TREATABILITY STUDY IN SUPPORT OF INTRINSIC REMEDIATION

HANGAR 10 SITE

ELMENDORF AIR FORCE BASE

March 1995

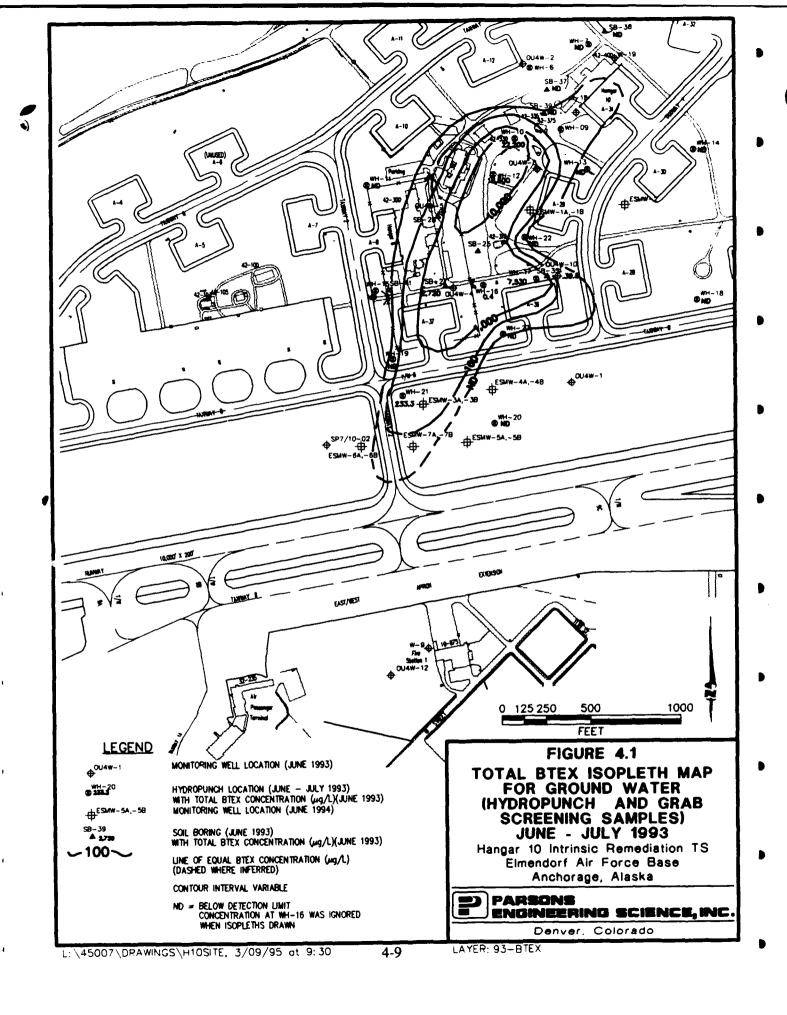
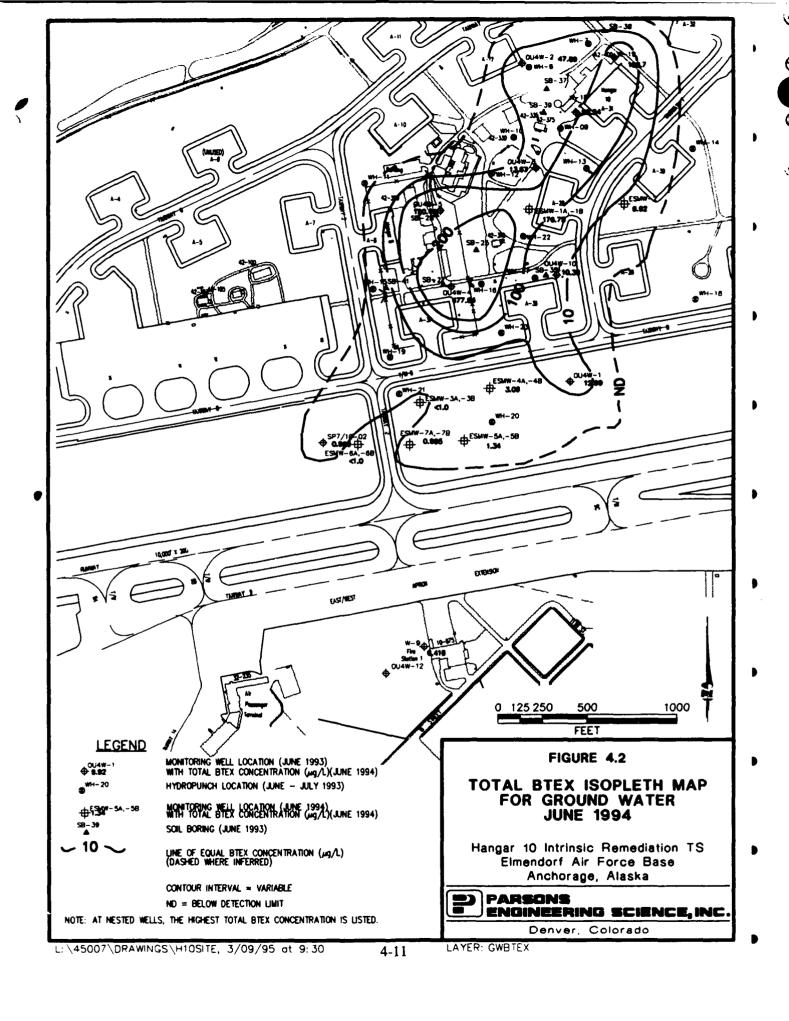
The isopleth maps (Figures 4.1 and 4.2) of total BTEX are misleading. Different data points were used (including different types of data such as HydroPunch^M and monitoring wells), and only a limited number of repeated data points were used. These maps appear to show degradation of the plume. When the actual data are reviewed, the results from several of the monitoring wells sampled repeatedly actually show an increase. The following table illustrates this increase:

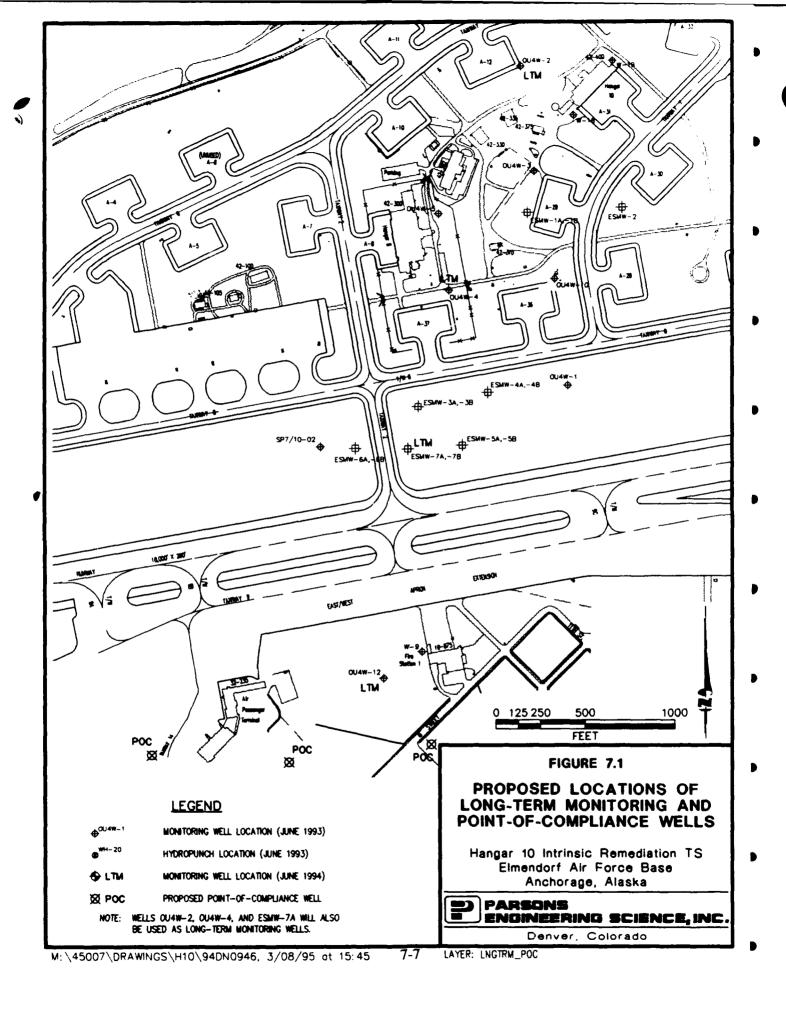
- 6. Figure 7.1. Can not put a LTM well between taxiway and runway. The well was supposed to be installed during the field effort 1994. I would say that we use ESMW-6A, ESMW-7A, W-9, OU4W-12, and one POC.

With respect to the other comments regarding point of compliance (POC) and LTM well placement, the plan outlined in Section 7 of the report is still recommended. LTM wells are intended to provide data throughout the length of the plume and the downgradient treatment zones confirming that biodegradation mechanisms continue to operate, and to further quantify the rates of BTEX loss. Therefore, OU4W-2, OU4W-4, and ESMW-7A should still be used as LTM wells, and the three POC wells indicated on Figure 7.1 should be installed. Given the width of the BTEX plume, placement of a single POC well to detect the plume would be risky. In addition, it is possible that local variations in the thickness of the outwash aquifer due to the uneven surface of the Bootlegger Cove Formation could locally affect ground water flow and contaminant migration, as indicated in Section 3.3.3.5 of the report.
